**EOG RESOURCES, INC.**  
**DOGWOOD 23 FED COM NO. 703H**

APD ID: 10400010755

In Reply To:  
3160 (Office Code)  
[ NMNM122622 ]

## Engineering Comments

# Exhibit 1 EOG Resources 10M BOPE

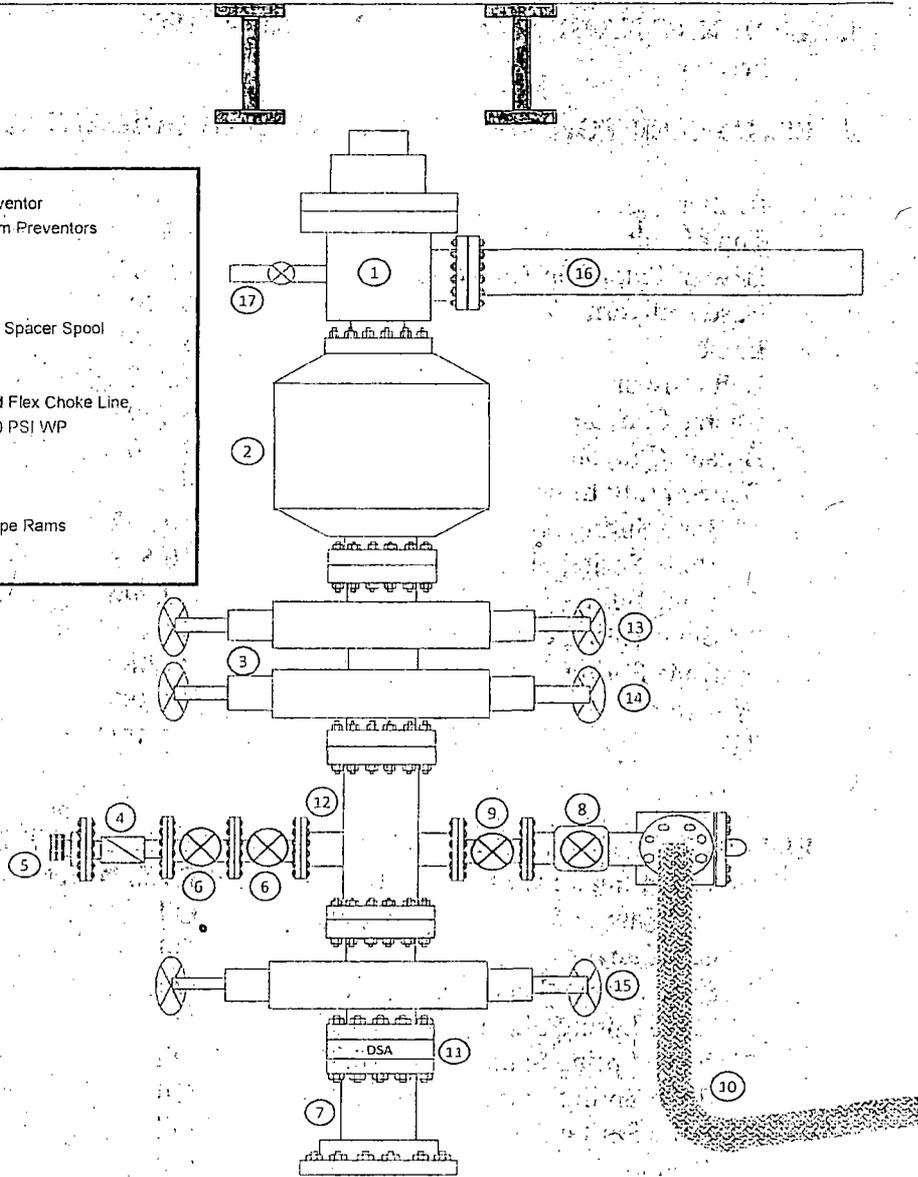
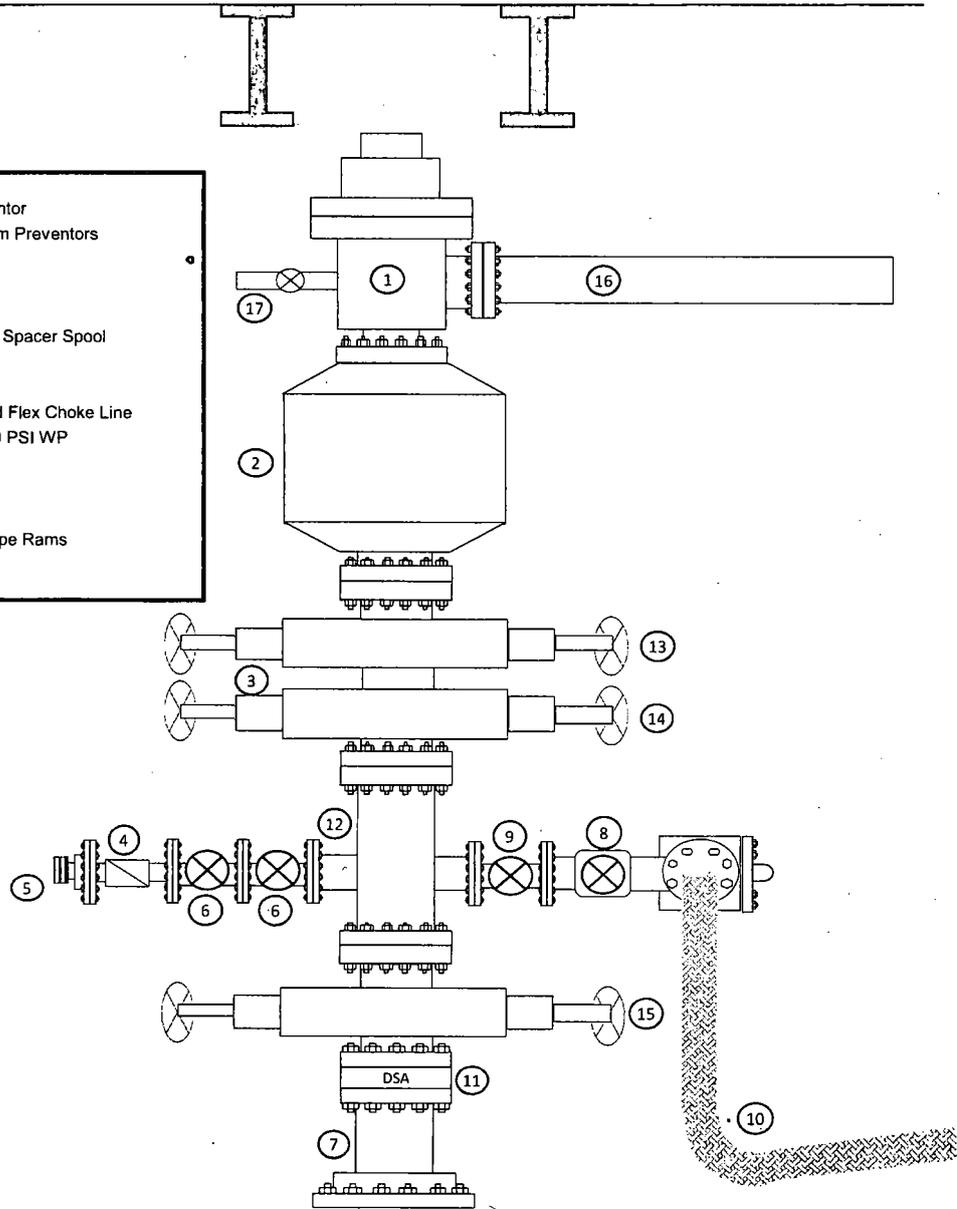
- BOP requirements are not met
  1. BOP Schematic must have a 10M Annular. Please resubmit with correction.
  2. 10M BOP Choke manifold is required. Please resubmit with correction.
- Engineering Review: Other identified drilling plan deficiencies  
Not a deficiency but cannot approve APD without a waste minimization plan. Please attach state submitted gas capture plan (this will be a sufficient substitute for waste minimization plan).
